Traffic Engineering Report

15 Anderson Street, Fortitude Valley

Proposed Build to Rent Scheme

Table 1.1: EDQ Comment Summary

PROJECT 15 ANDERSON STREET	DRAWING TITLE GROUND FLOOR	SCALE 1:250 @A3	
15 ANDERSON ST FORTITUDE VALLEY QLD 4006		DATE 13/12/2023	
		DRAWN LH	PLOT DATE 13/12/2023
		CHECKED TC	CHECKED TC
		JOB NO. 21026	REVISION 15
		DRAWING NO. TP100

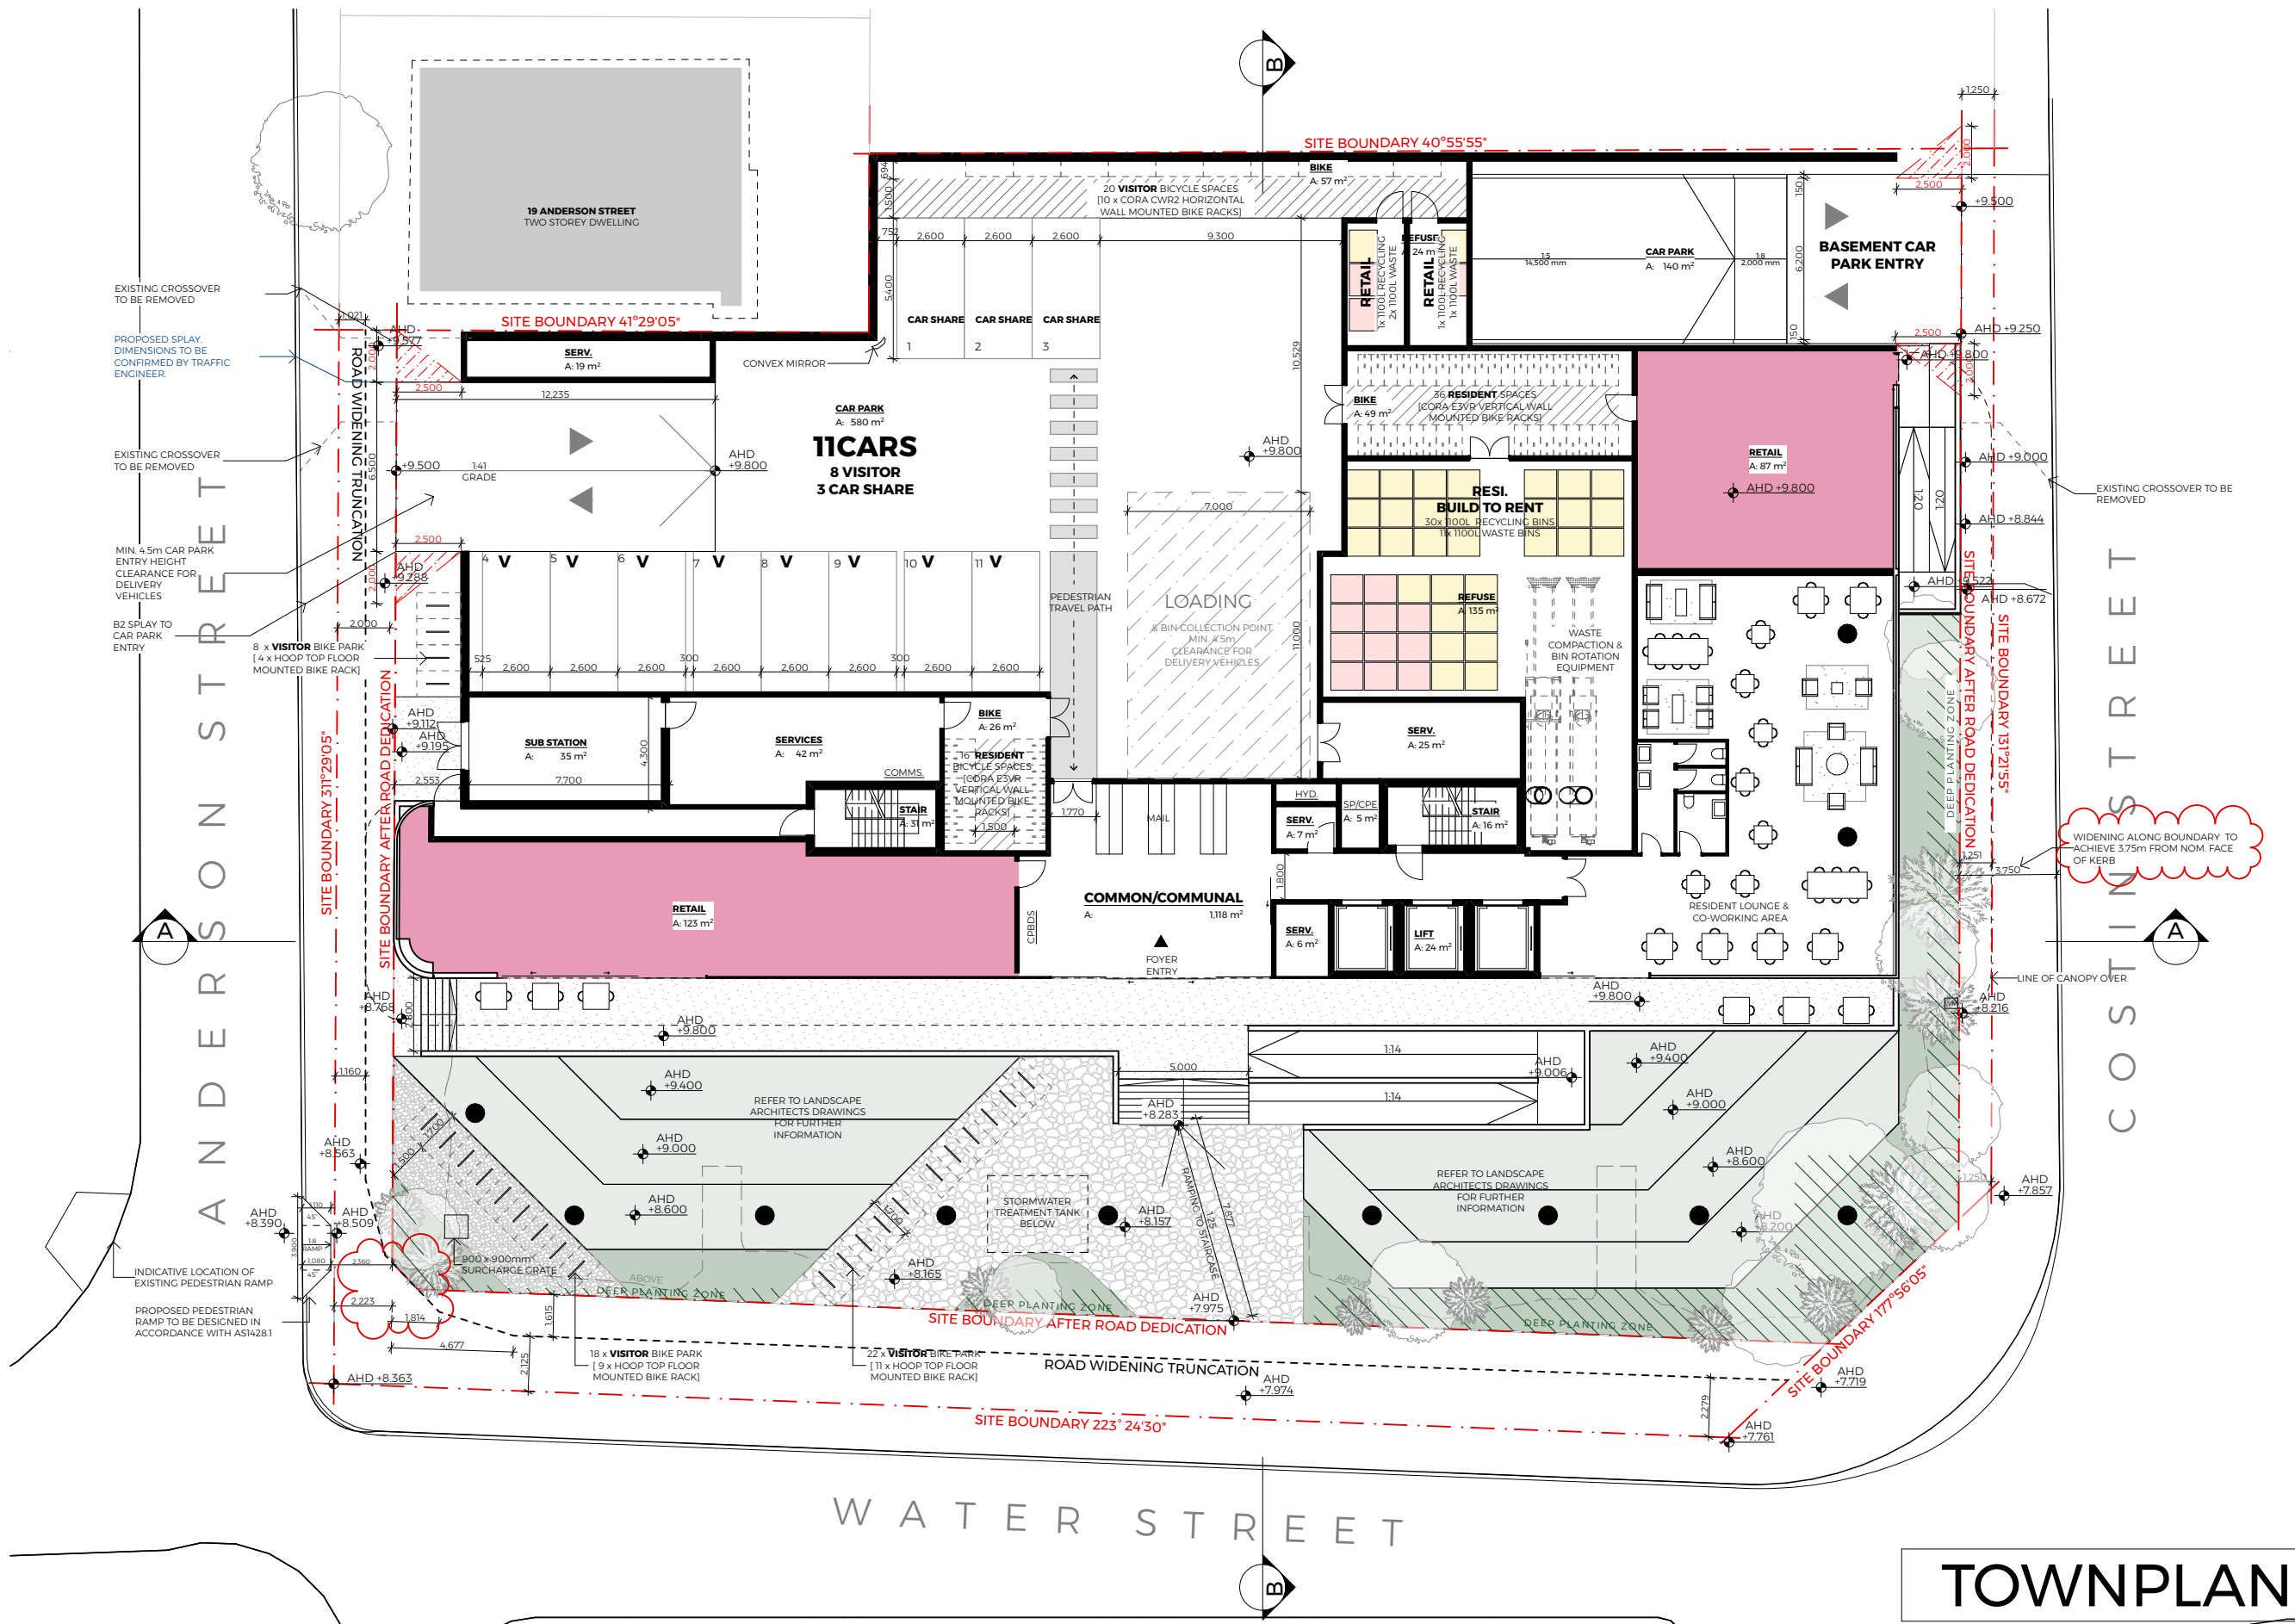
boundary.	
Carparking spaces that have a width of 2.3m and 2.4m are to be designated as “Small Car spaces” on the plans. In accordance with TAPS, up to 20% of spaces may be small car spaces provided they are no smaller than 5m long by 2.3m wide and are appropriately signed. In addition to this, submit amended plans to show that vehicles using visitor spaces 3, 4, 5, 6 can safely enter and exit these bays when an RCV is present in the servicing area.	All 2.3m wide bays are to be nominated as ‘small car bays’. Bays at 2.4m are standard bays. Refer to Section 4.4.3 for further information. Visitor bays 3 – 6 have been removed.
It needs to be demonstrated that the carparking spaces that contain wall mounted bicycle storage racks in front of the car parks will have sufficient room and that the racks and bicycles will not intrude into the parking envelope, thus reducing the length of the actual space for the car/van to park.	The proposed parking supply includes bicycle parking above bonnet within the resident parking area. A reduced height clearance above bonnet is typical as this space would be otherwise wasted. The height clearance would reduce, but still allow for the functional use of the space. Note that these spaces can be removed from the total parking supply, with the number of standard bicycle spaces meeting the minimum requirements of Austroads Guidelines.

EDQ have noted that bays with a width of 2.3 – 2.4m are to be classed as small car. The intent is that only bays with a width of 2.3m are to be classed as small car. A 2.4m width complies with AS2890.1 requirements for a residential bay. It is noted that these bays are accessed via a 6m (min) wide aisle, which is wider than the standard 5.8m aisle noted in AS2890.1. On this basis, manoeuvring to/from the space is not impeded.

D01 DETAIL 02 - CAR PARK
SCALE: 1:100@A1

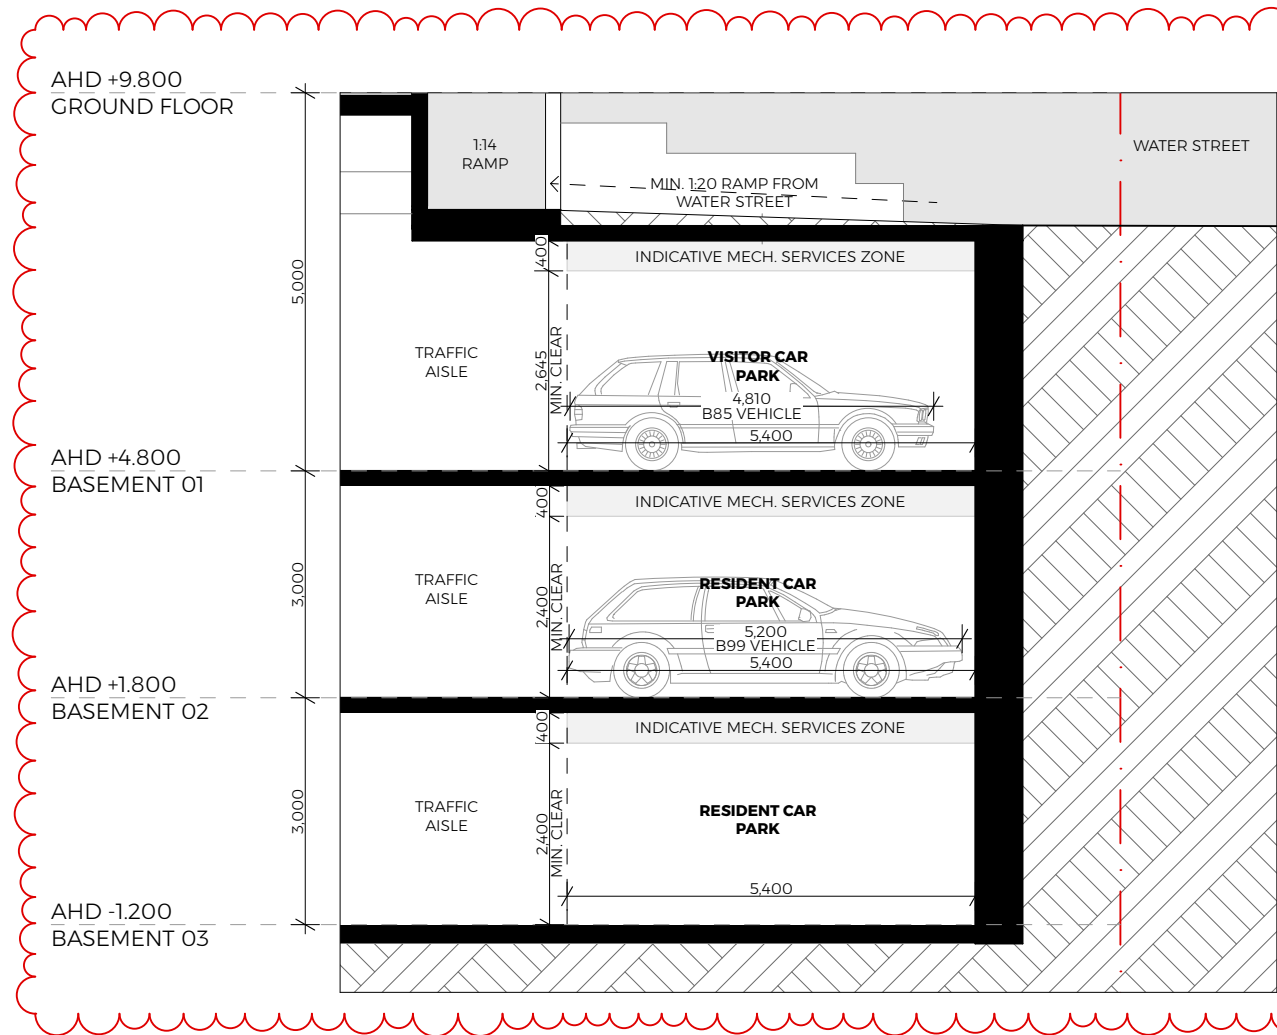
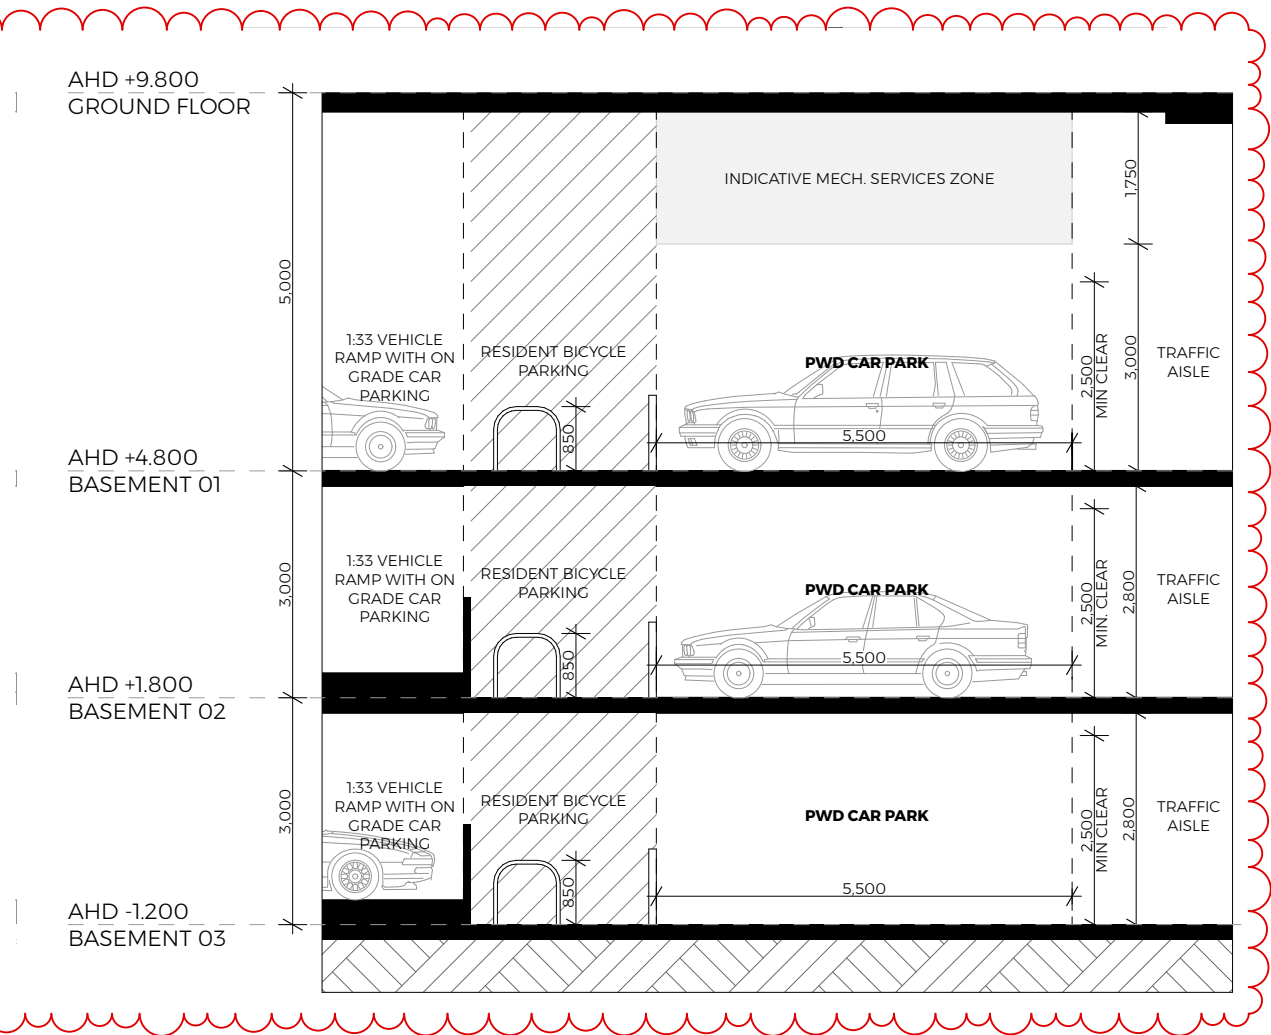
<p>The plans do not clearly show that height clearances for the basement and in particular PWD spaces will meet those required in TAPS. In particular it is not clear from the drawings what the slab thickness will be and what fittings/piping may be attached to the underside of the floor slab. Provide amended plans which clearly demonstrate that the minimum height clearances for basement levels will be met.</p> <p>Alternatively, provide a statement in the TIA confirming compliance of the height clearance.</p>	<p>Section included in Appendix A.</p> <p>Clear height clearance above PWD bay is 2.5m.</p>
<p>Provide amended plans which dimension the road widening and corner truncation at the corner of Anderson Street / Water Street to indicate compliance with the verge widths (it is acknowledged that measurements shown in DAWG TP100 would appear to indicate that the required verge widths have been provided).</p>	<p>Plans updated – refer to Appendix A</p>
